**ADDENDUM NO. 01**

**Dated: Jan. 13, 2023**

**Project No.: 16640E-01-02**

**Description: Ziehler Playground**

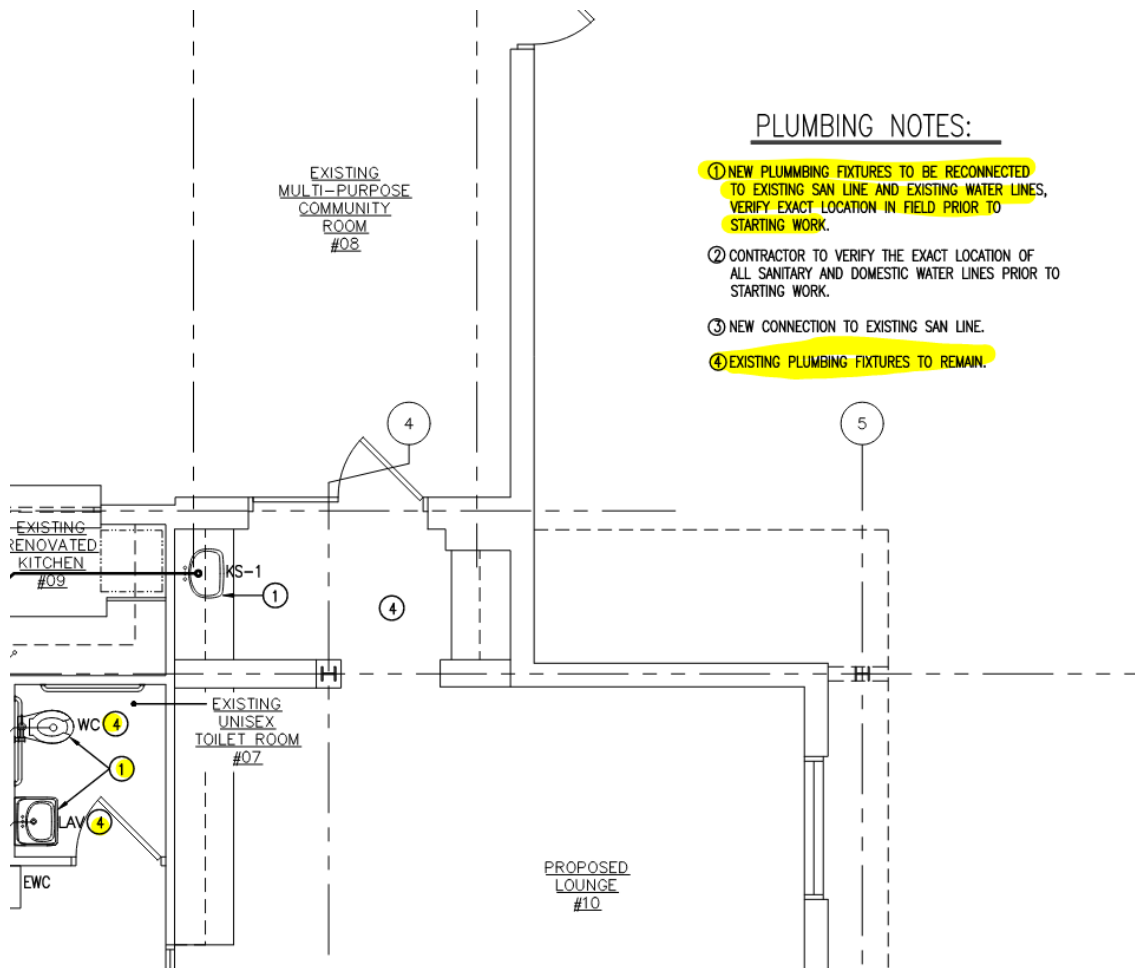
9. Drawings E-0.2 and E-3.1: Are the electric panels new as shown on E-0.2 or existing as shown on E-3.1?

**ANSWER: All Panels and Electrical Service Equipment will be new.**

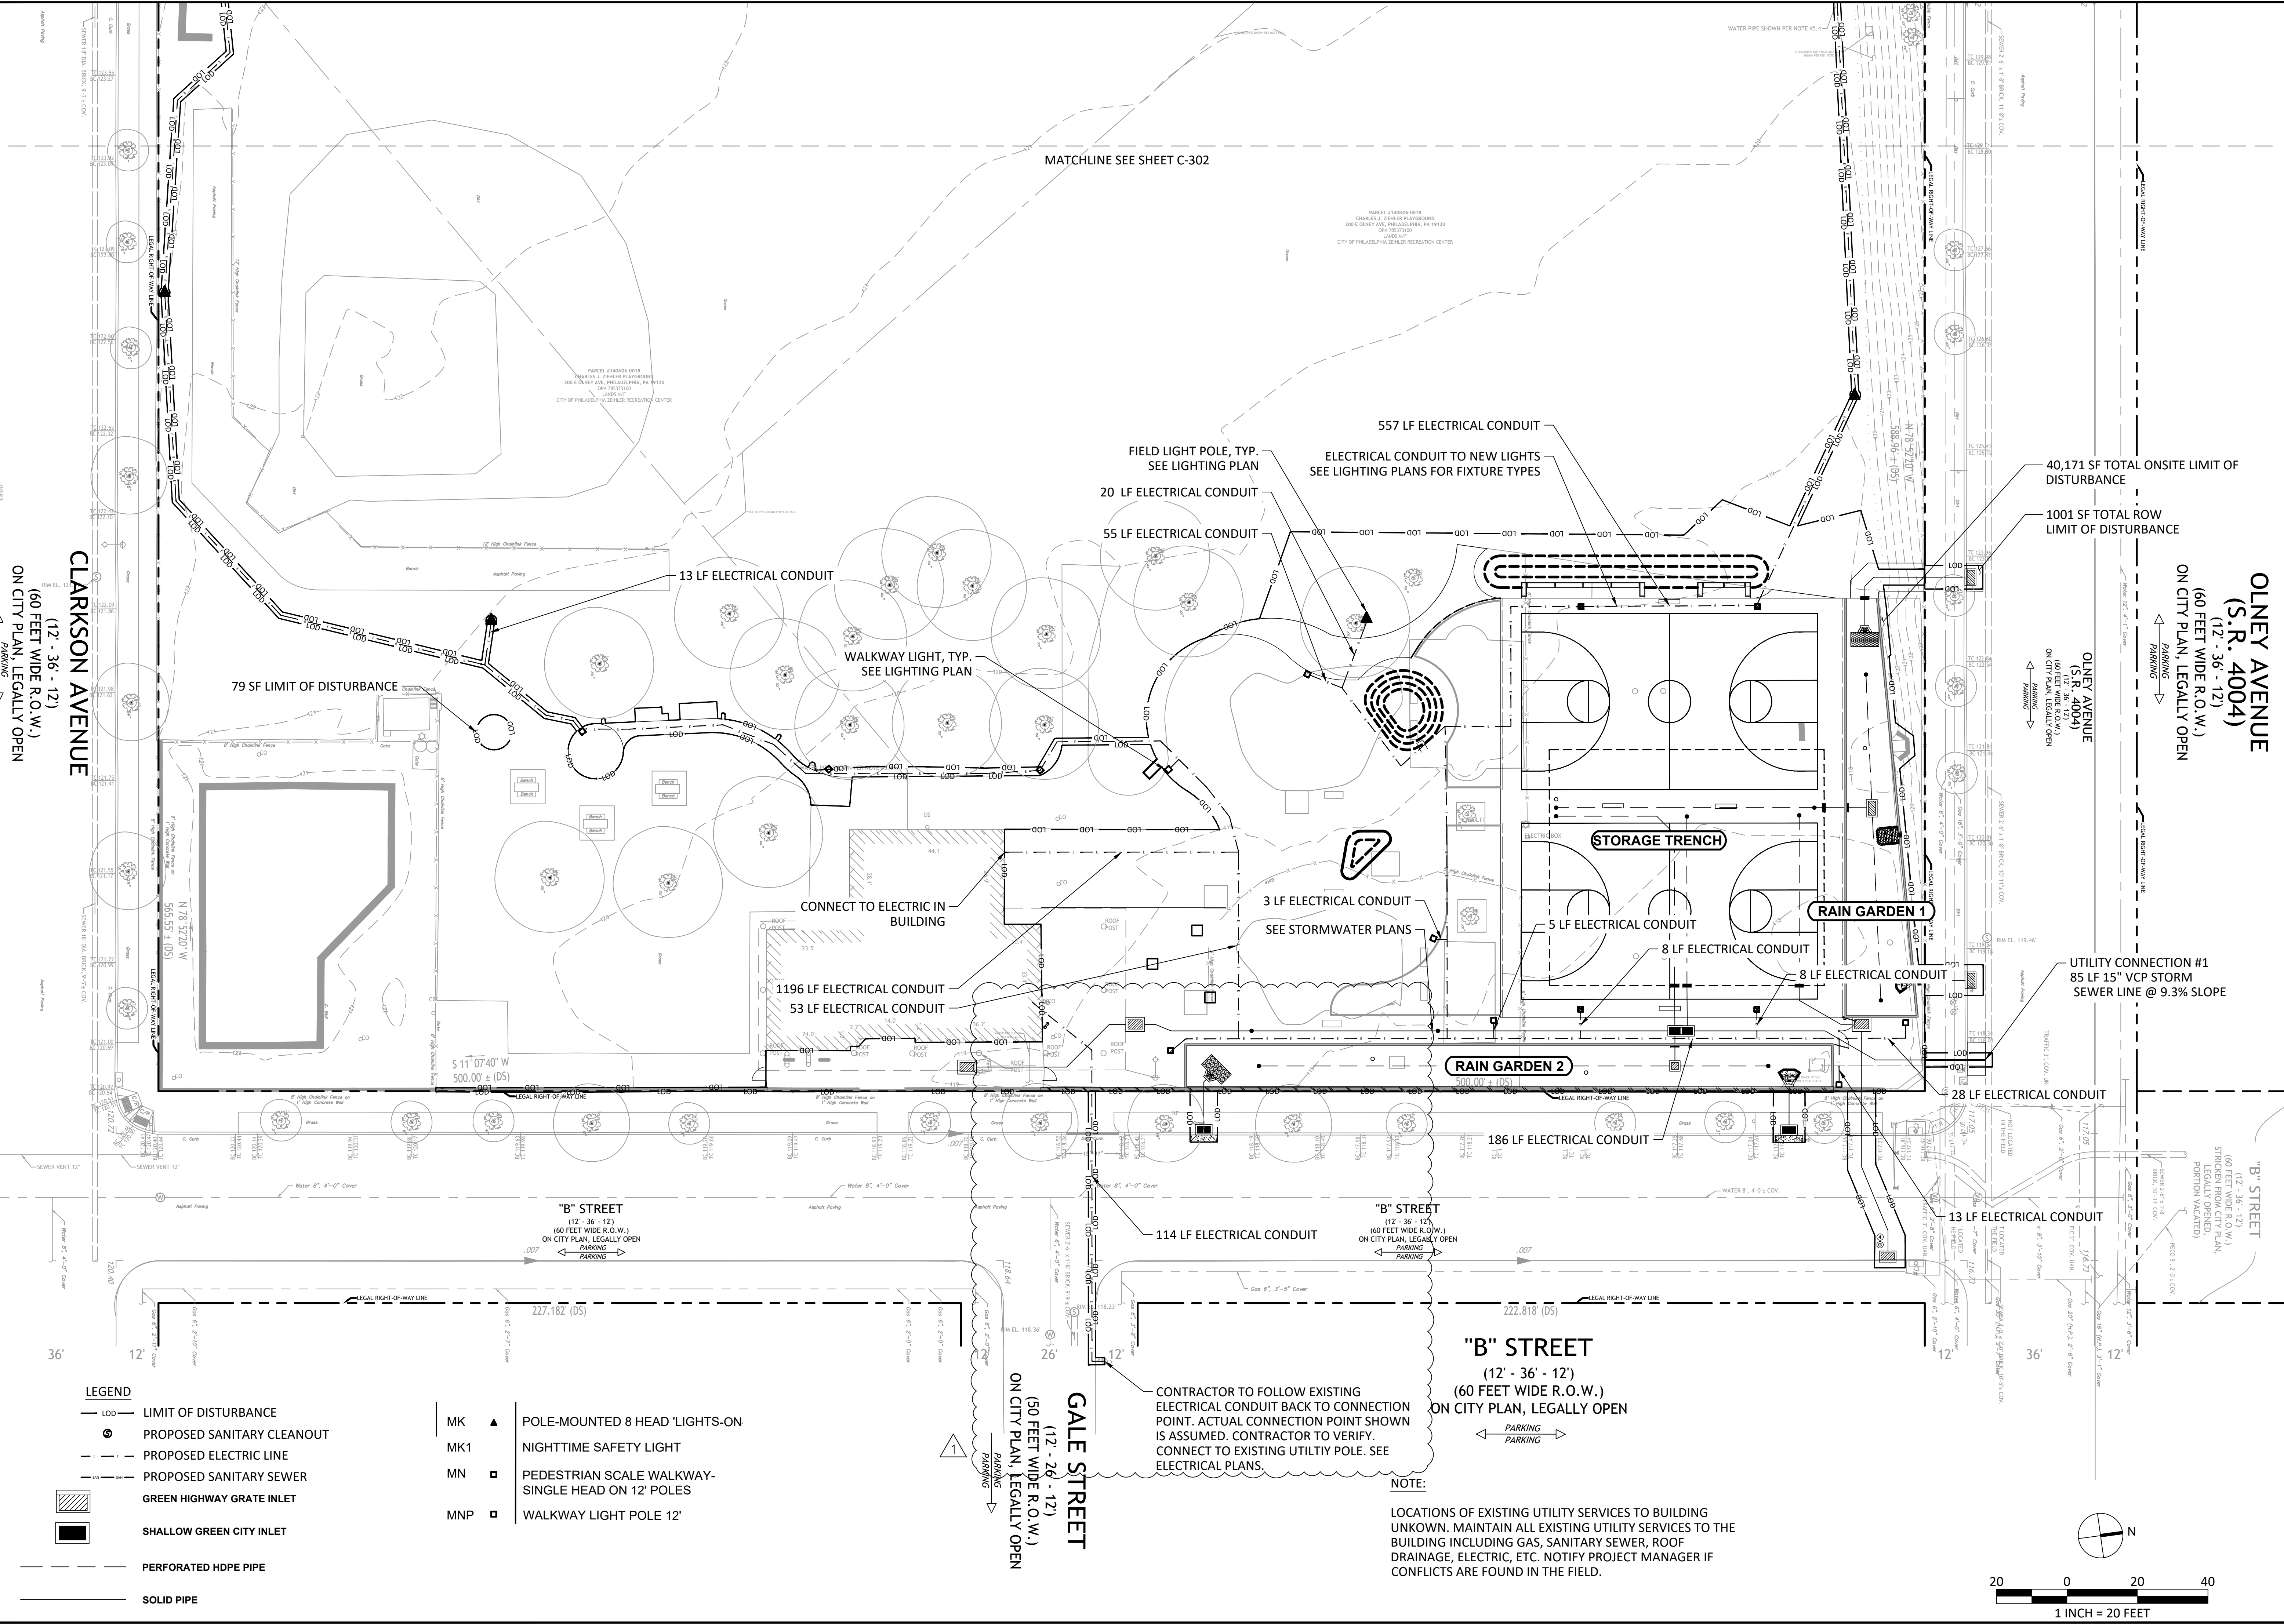
35. Sheet AD1.00 says the existing columns and beams at the future canopy are to remain. Sheet S1 says the same columns get removed, reinforced and reinstalled. What scope are we to include in our bid?

**ANSWER: The columns are to be salvaged, reinforced, and reinstalled per structural drawing S1. Note that in addition, the existing foundations are to be demolished and new foundations installed.**

SHEET NUMBER:  
**E-0.1**

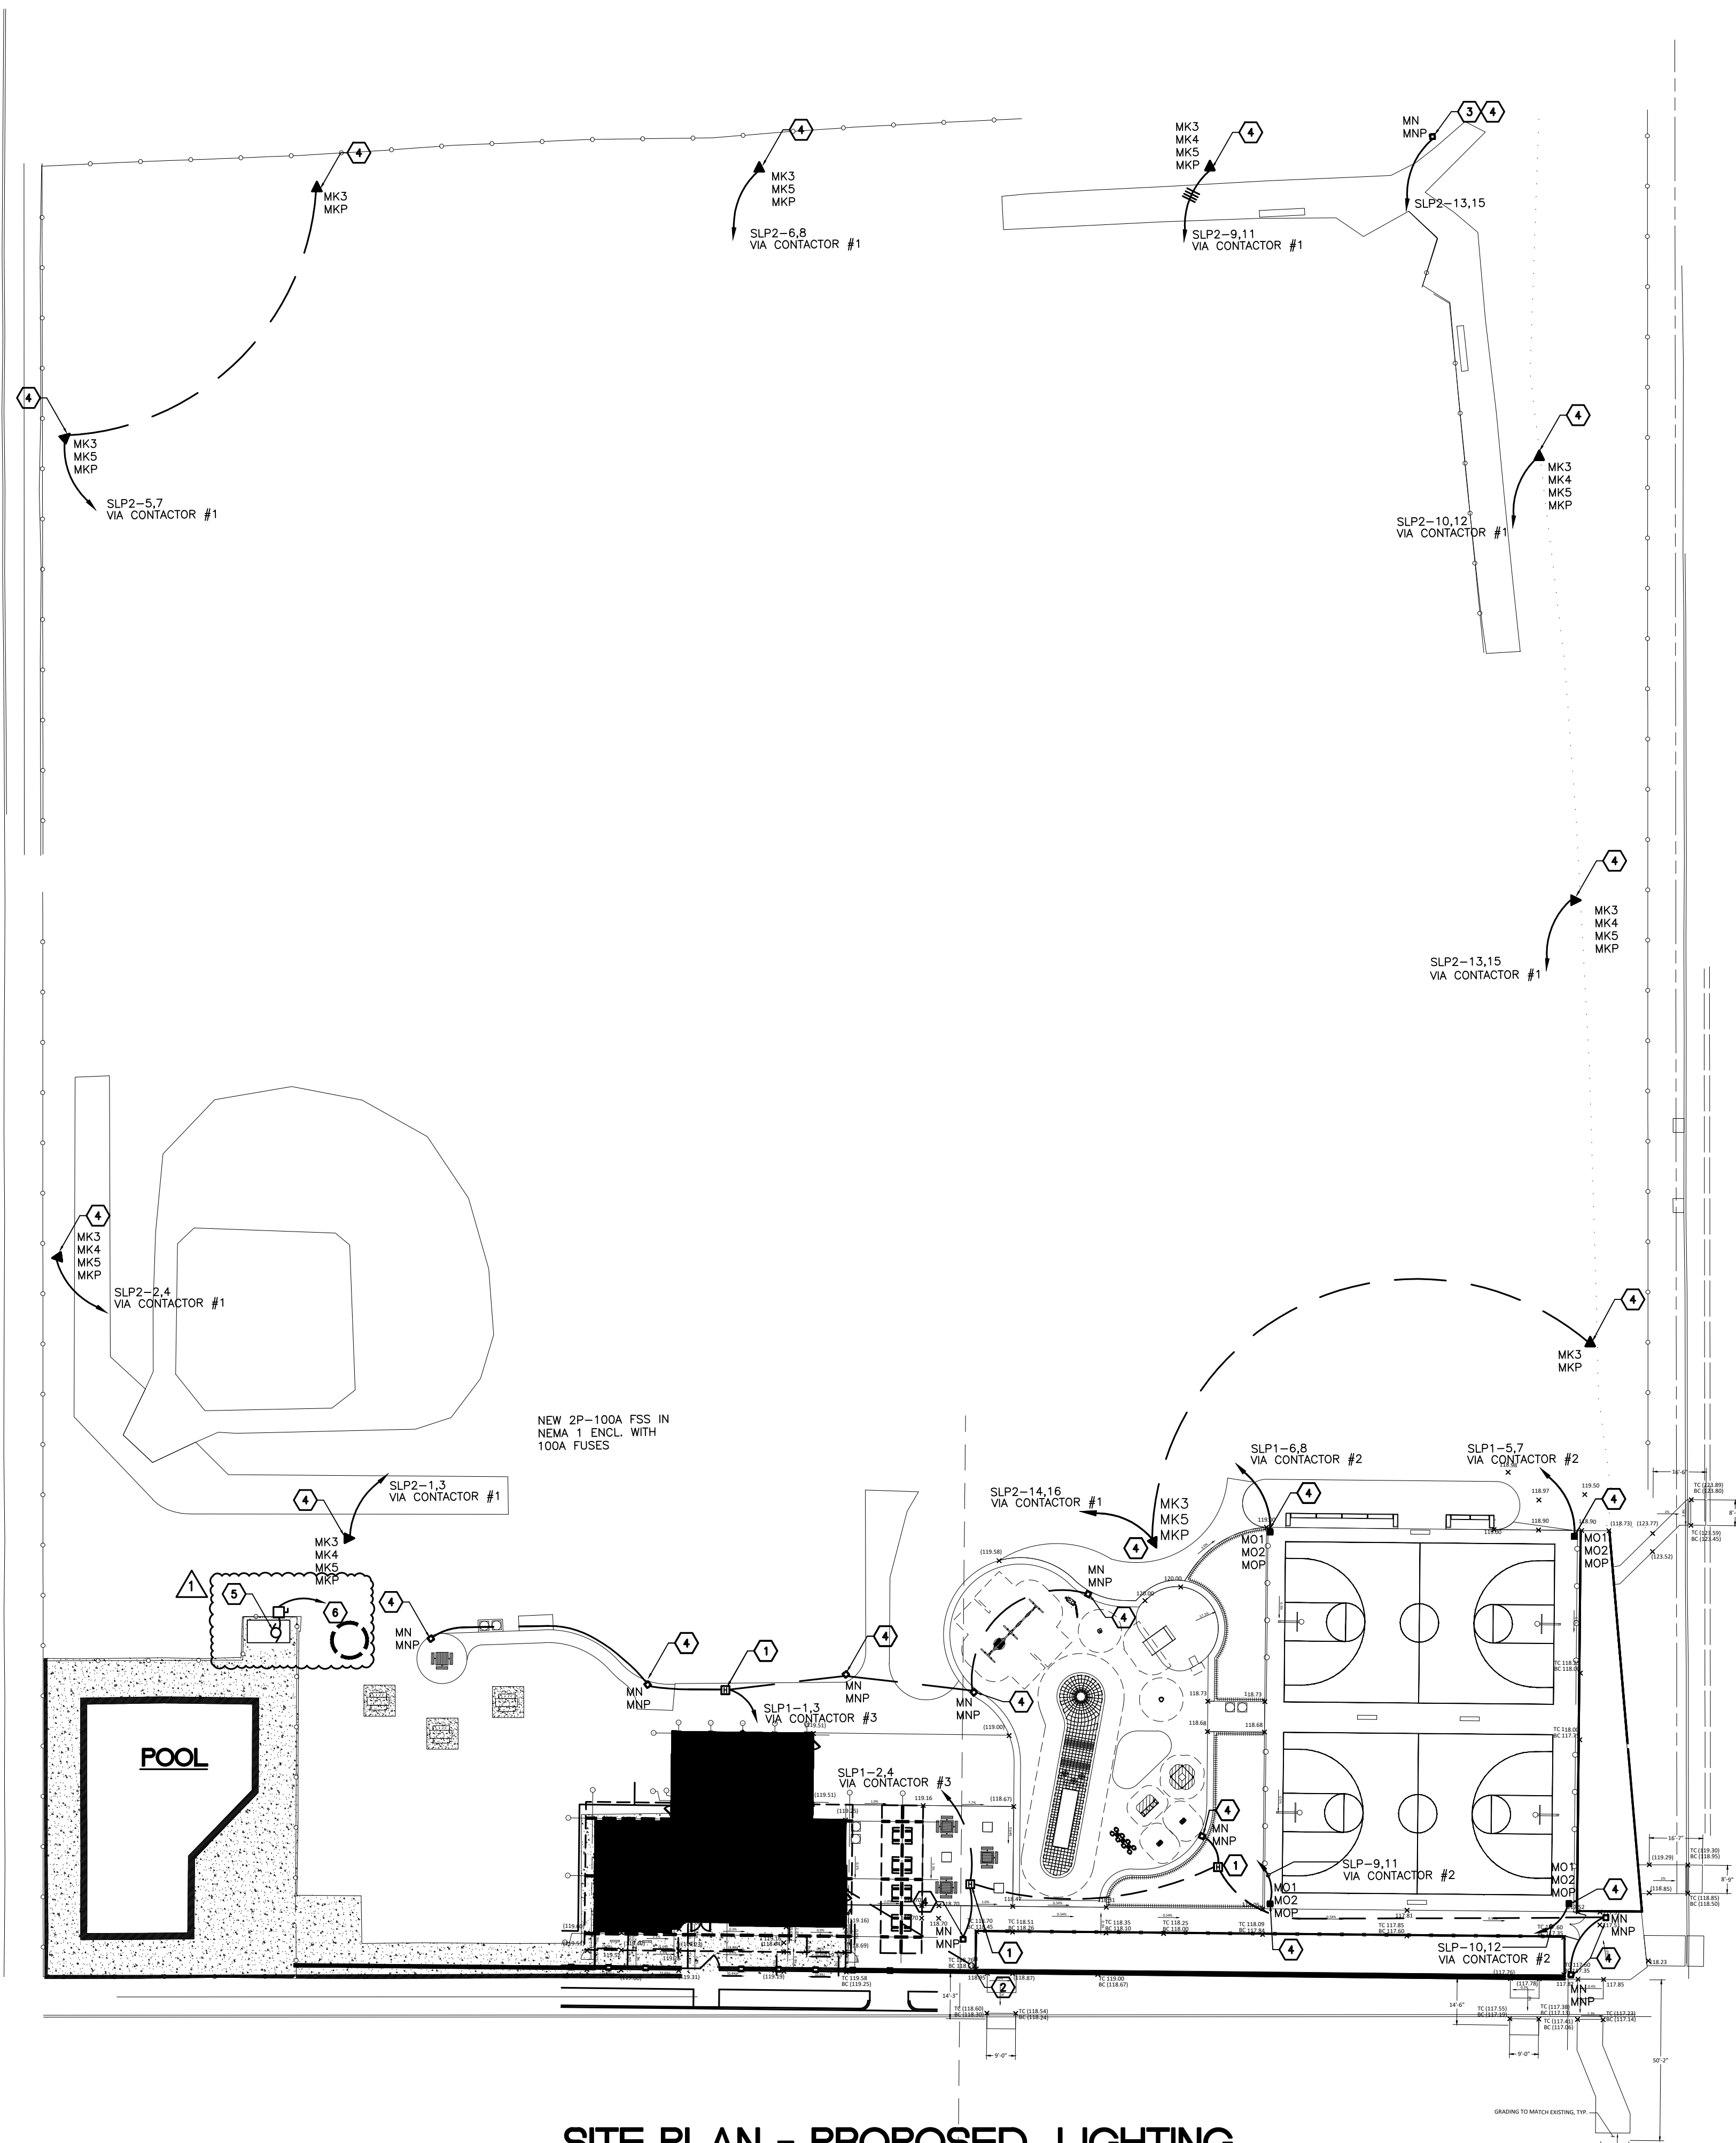
- e. Drawing “E-0.1 Site Plan-Electrical” updated drawing notes # 5 and #6 and provided location of existing PECO Service Pole.
  - f. Drawing “E-0.2 Site Plan-Details and Power Riser Diagram” updated notes # 3 & #4 revised to show location of pool equipment.

3. Where do electric service conduits run to for PECO service? Was a Service & Meter request filed for new service requirements from PECO? Civil Drawings do not show service excavation or "LOD" for new service.

**ANSWER: Service & Meter request is in the process of being filed. See Addendum 1 for note #2 on drawing E-0.1 identifying location of existing PECO Service Pole. Contractor shall field coordinate additional details with PECO Field Engineer. See Addendum 1 for updated drawing C-301 which shows service excavation within LOD.**

- 1 NEW HEAVY DUTY GROUND MOUNTED HAND BOX. CONTRACTOR SHALL SIZE PER NEC. FIELD COORDINATE LOCATION WITH OTHER UNDERGROUND SITE UTILITIES.
- 2 CONTRACTOR SHALL REMOVE EXISTING UNDERGROUND ELECTRICAL SERVICE TO THE BUILDING BACK TO UTILITY CO POLE. PROVIDE 2 NEW UNDERGROUND CONDUITS PER DETAILS 'H' AND 'J' ON DRAWING E0.2. FIELD COORDINATE ROUTE WITH PECO AND OTHER SITE UTILITIES.

- 4 REFER TO STRUCTURAL DRAWINGS FOR BASIC POLE DETAIL.
- 5 CONTRACTOR SHALL FIELD VERIFY THE LOCATION AND CONDITION OF THE EXISTING POOL EQUIPMENT. IF NEW POOL EQUIPMENT IS REQUIRED, CONTRACTOR SHALL ADVISE OWNER AS THIS WILL BE PROVIDED UNDER SEPARATE AGREEMENT.

- 6 CONTRACTOR SHALL REFER TO DRAWING E-3.1 FOR ADDITIONAL INFORMATION ON NEW FEEDER TO POOL PUMPS. CONTRACTOR SHALL REUSE THE EXISTING CONDUIT IF THEY DEEM IT TO BE SAFE AND INTACT.

**SITE PLAN-DETAILS AND POWER RISER DIAGRAM**

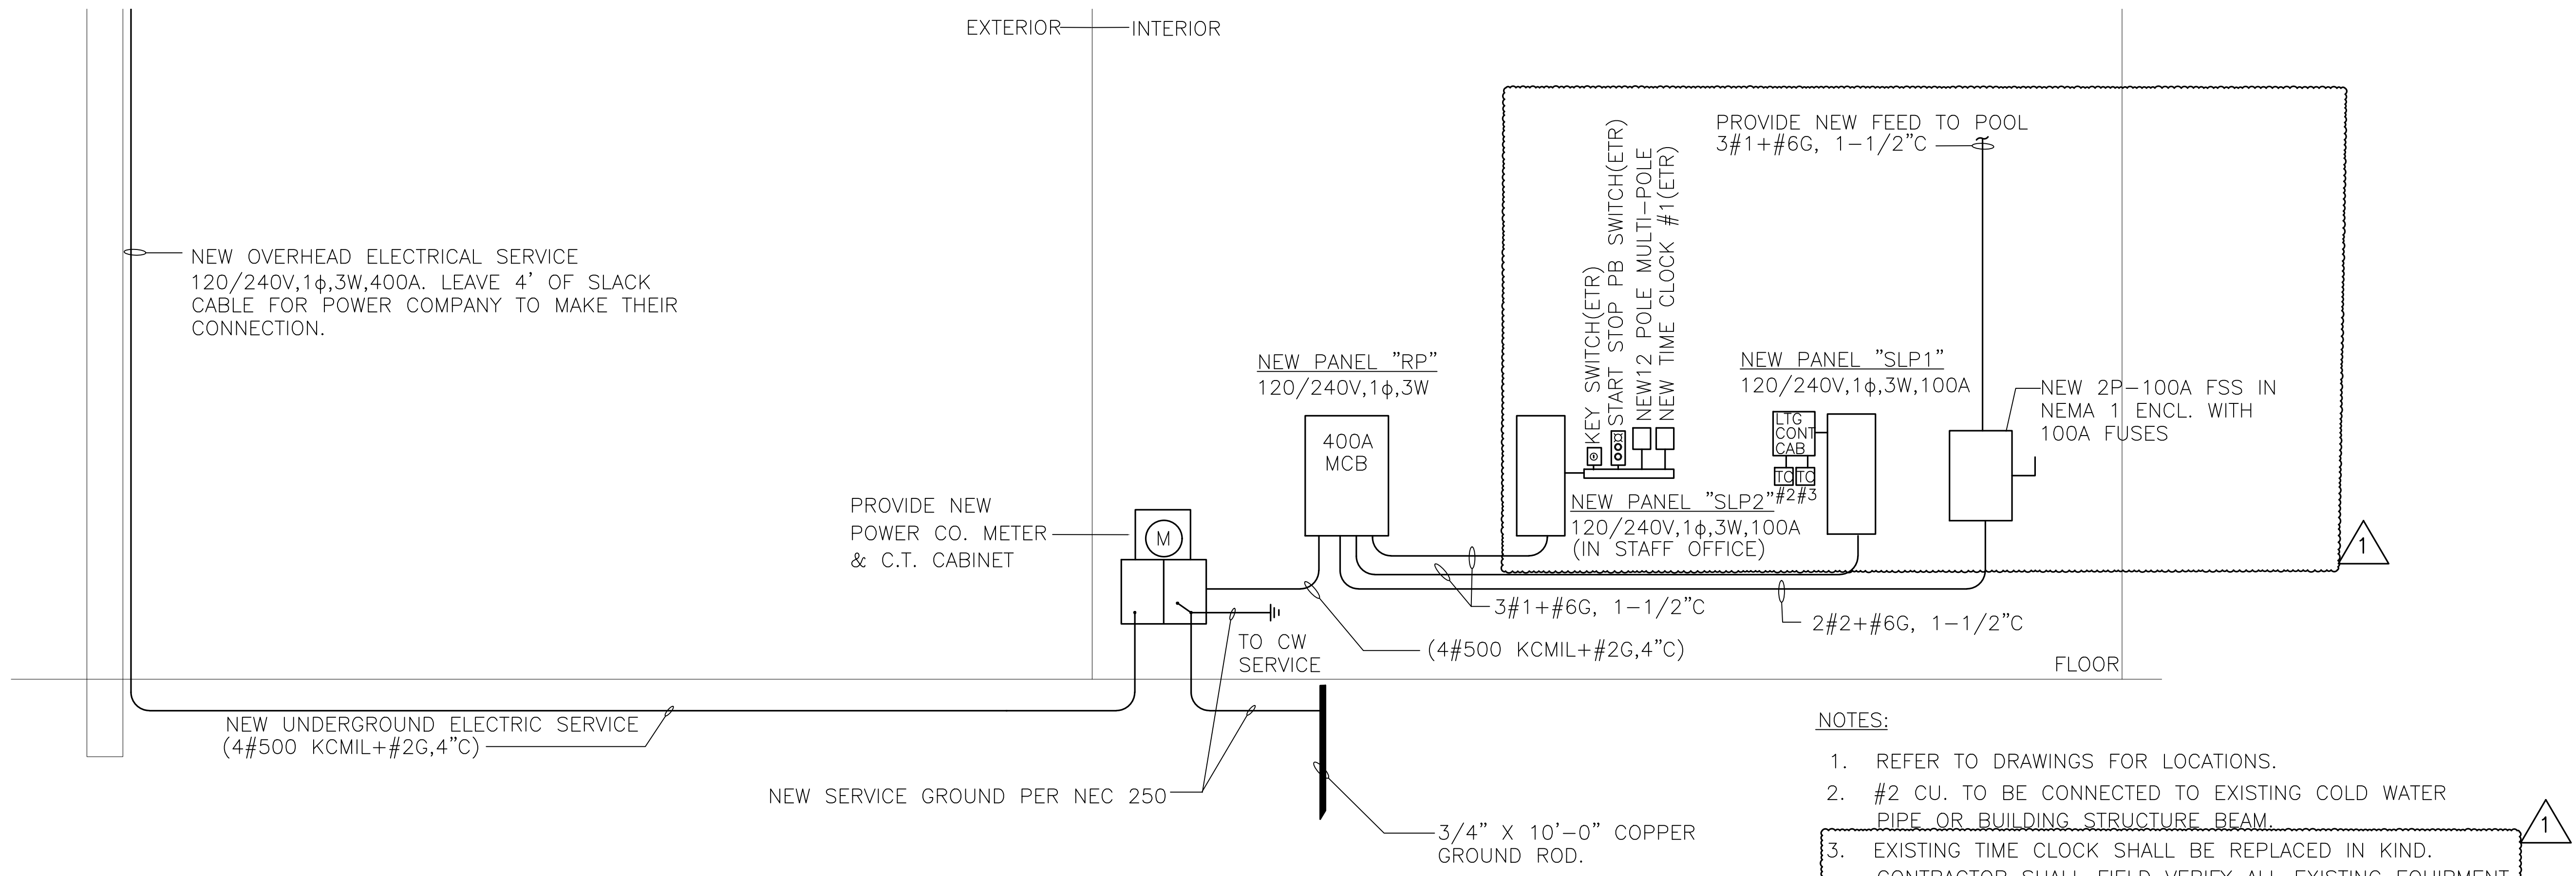
8. Drawing E-0.2, "New Feed to Pool": Can you provide a drawing with location of pool equipment we are required to re-feed?

**ANSWER: Location of pool equipment is shown on revised electrical plans per Addendum 1. Verify on Civil Drawings.**
